ADMINISTRATIVE AMENDMENT

PROJECT
Las Lomas Plaza-Administrative Amendment
2101 Vista Oeste
Albuquerque, NM 87120

TITLE
Architectural Site Plan

A001

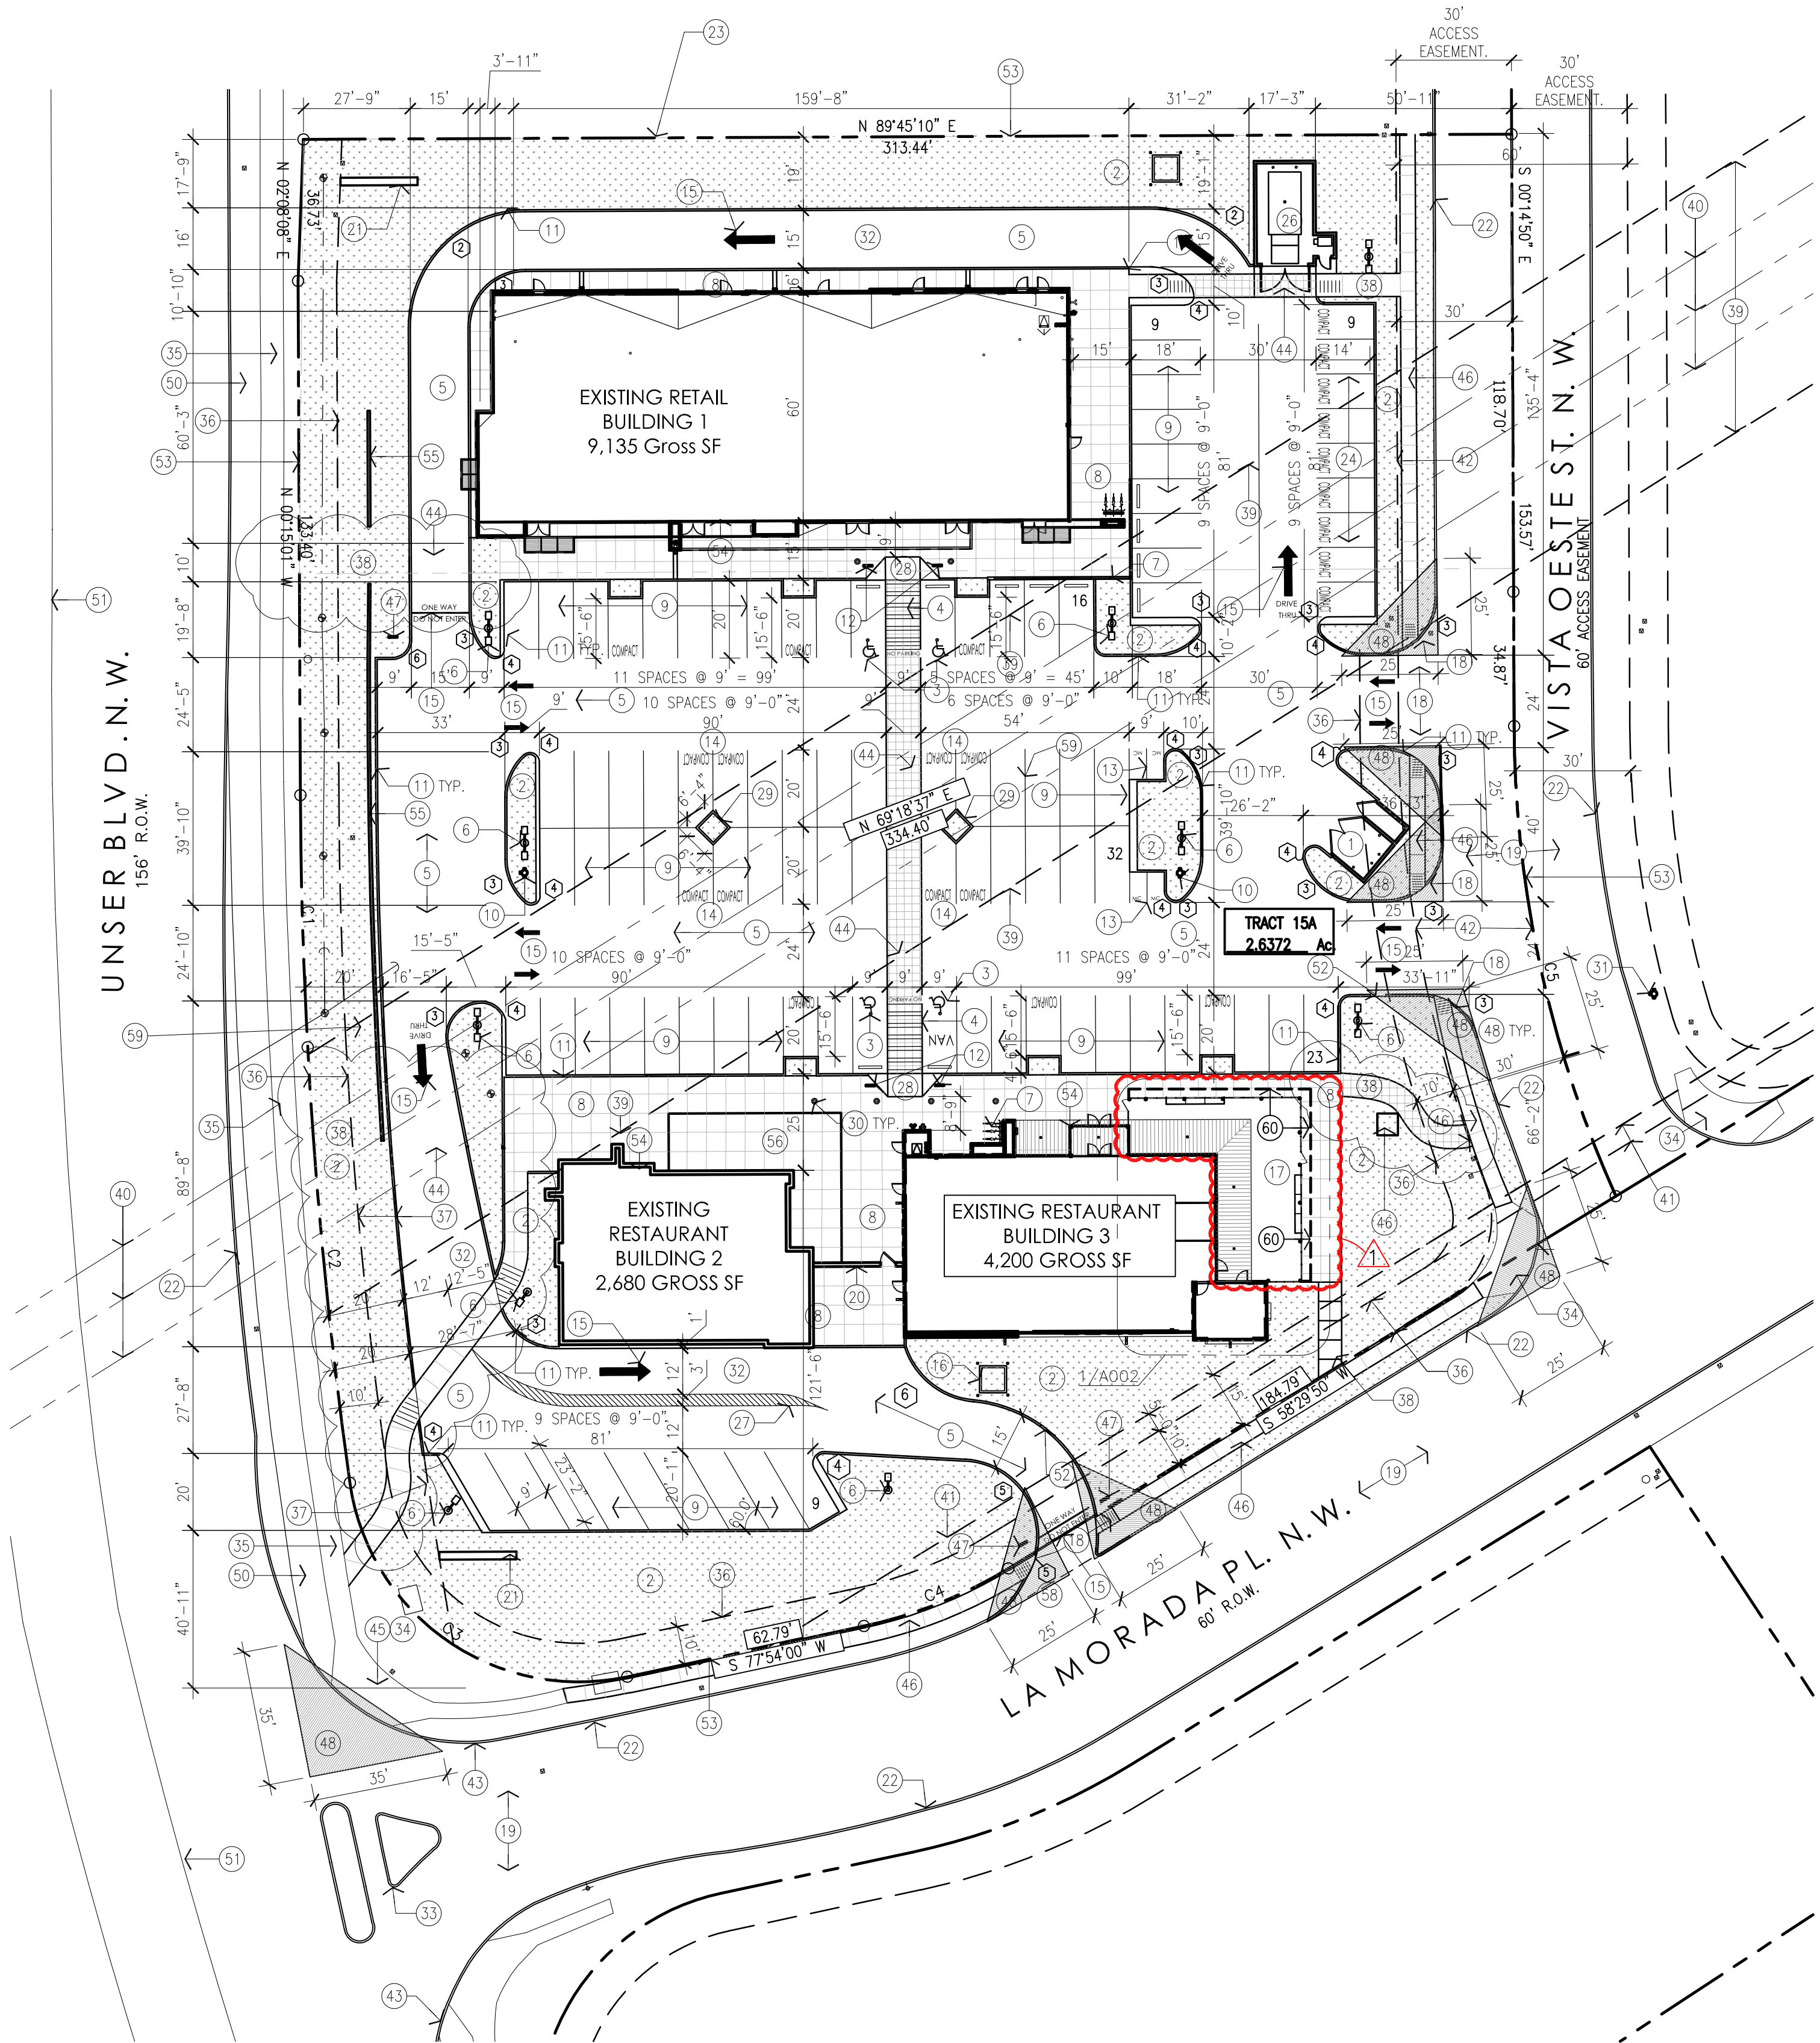
- [58] PROPOSED RIGHT-TURN ONLY PAVEMENT MARKING.
- [59] EXISTING LOT LINE TO BE ELIMINATED BY PLAT.
- [60] NEW CANOPY OVER EXISTING OUTDOOR PATIO.

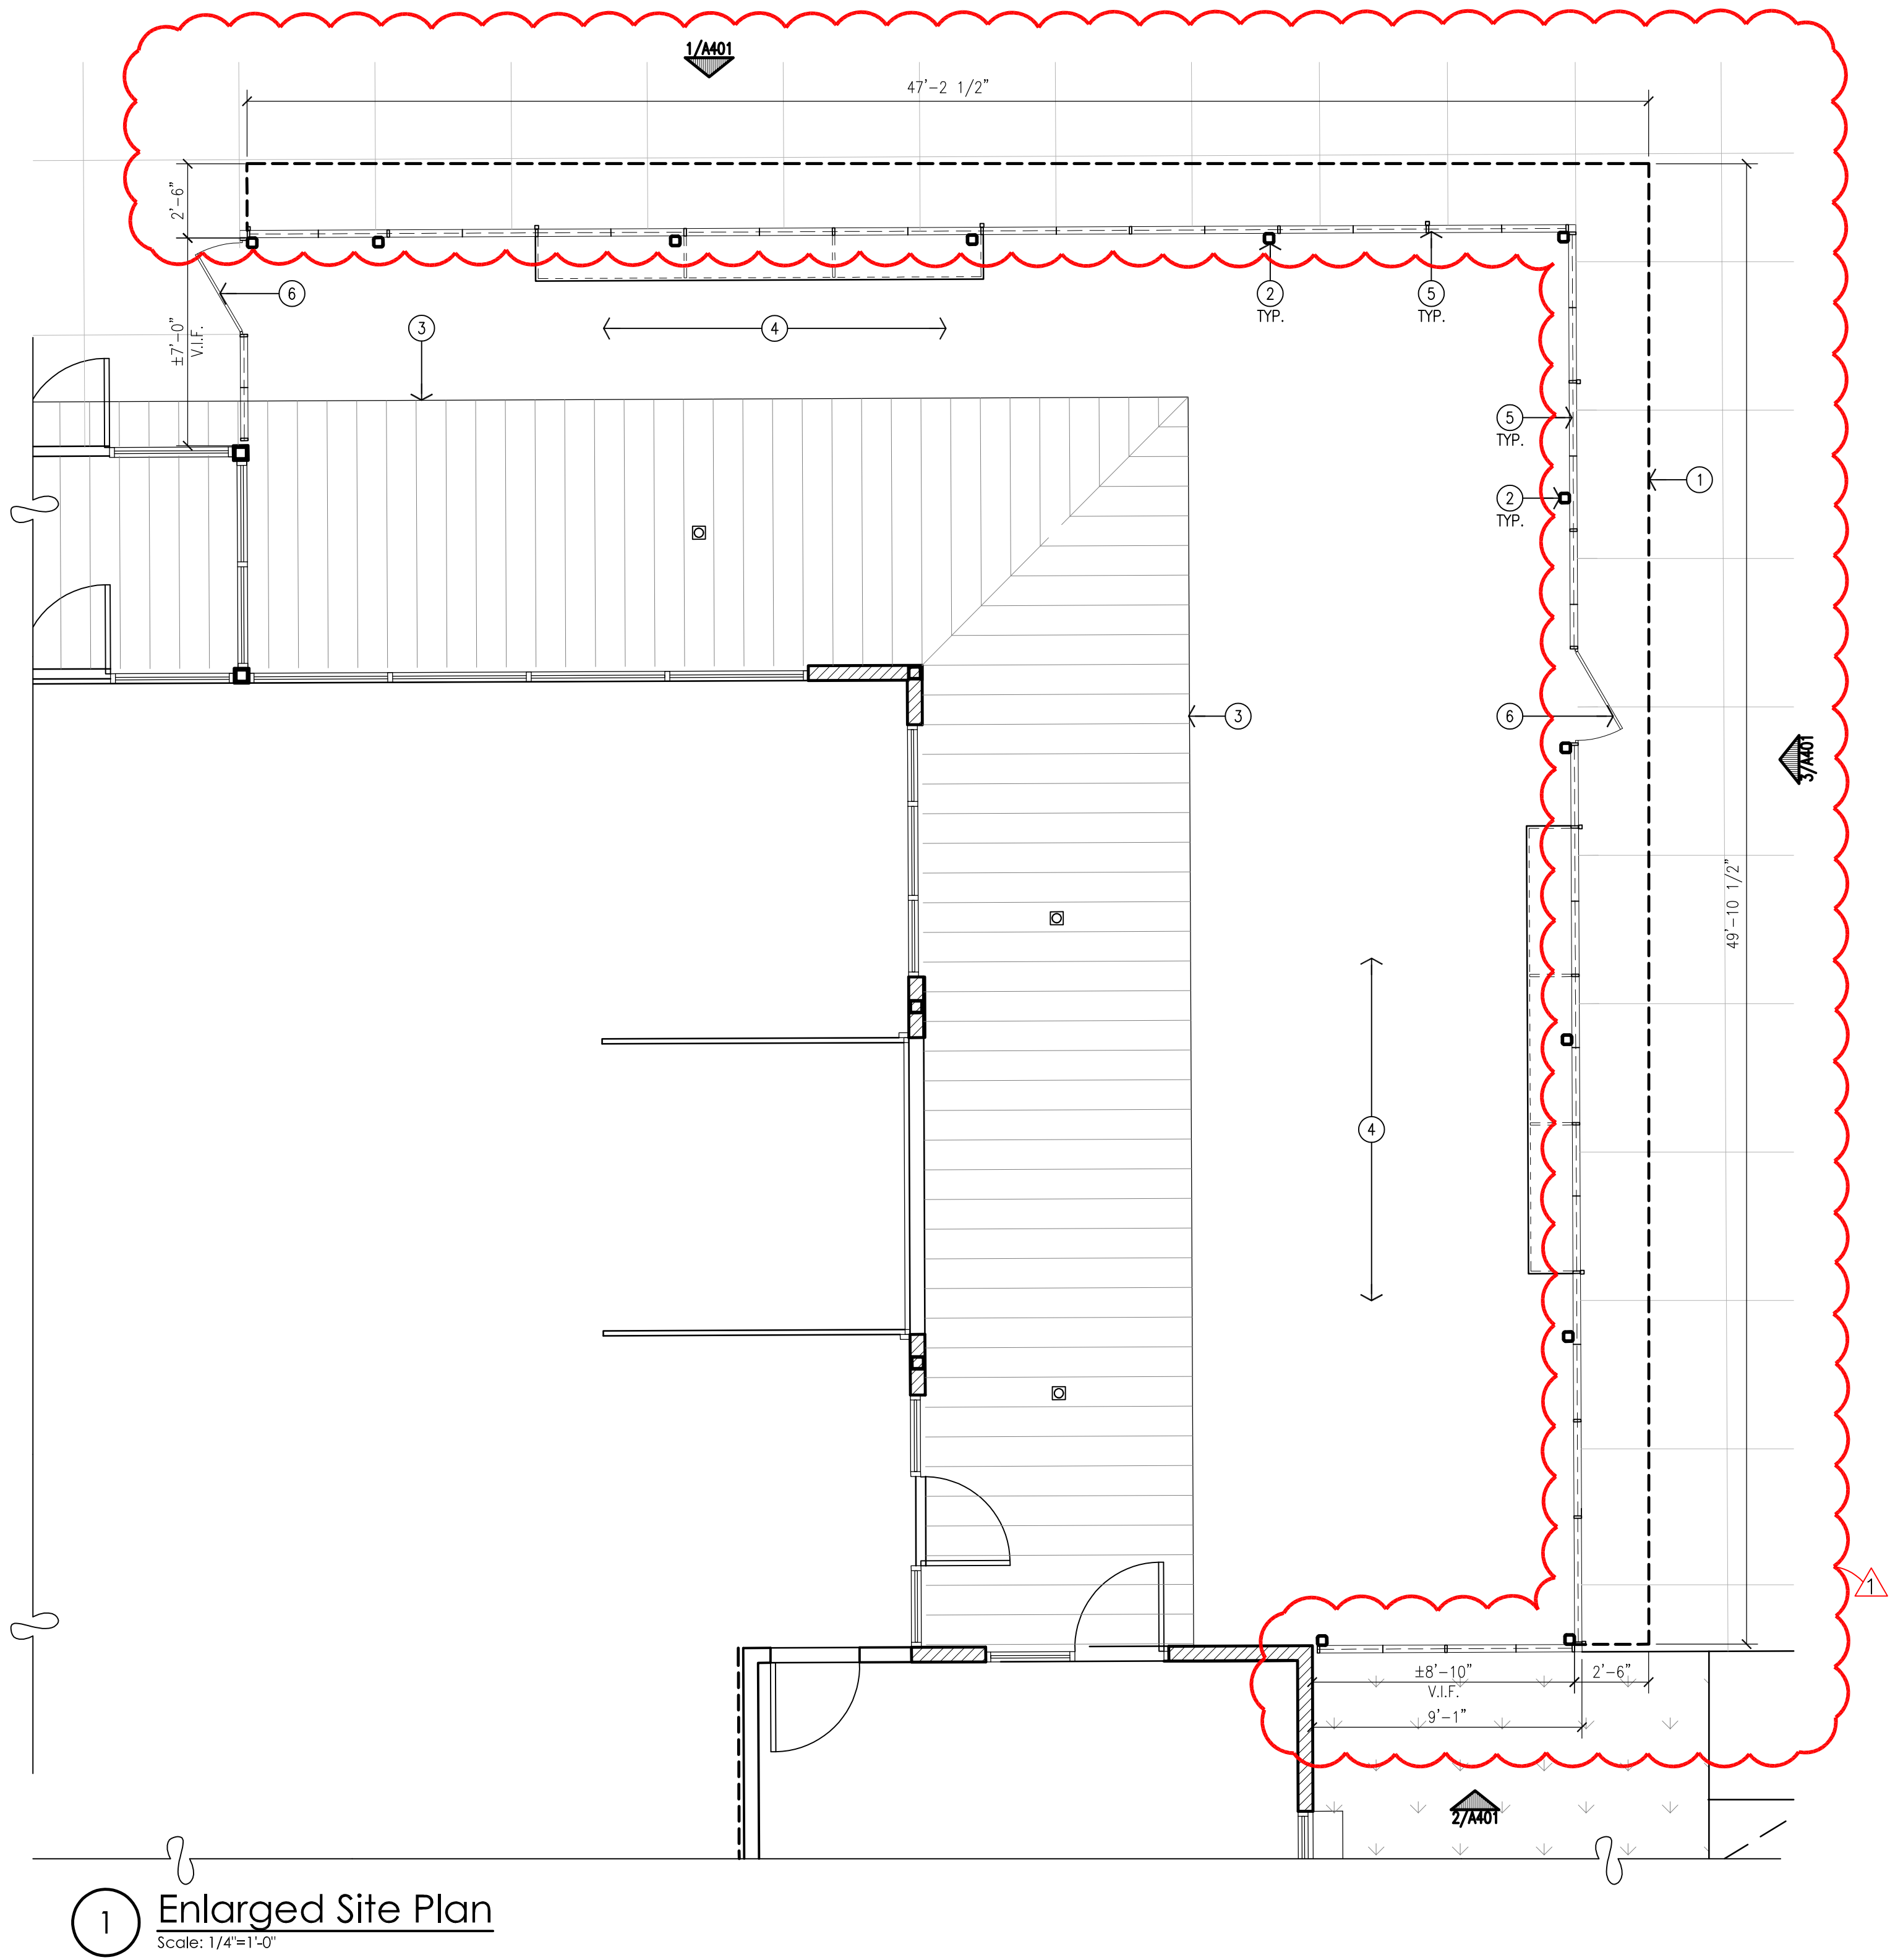
- KEYED NOTES:
- [1] NEW METAL CANOPY OVER EXISTING OUTDOOR PATIO
COLOR: DARK GRAY TO MATCH EXISTING.
 - [2] NEW STEEL COLUMNS. REFER TO STRUCTURE.
 - [3] LINE OF EXISTING CANOPY ABOVE.
 - [4] EXISTING CONCRETE PATIO.
 - [5] EXISTING TUBE STEEL RAILING.
 - [6] EXISTING PATIO EXIT GATE.
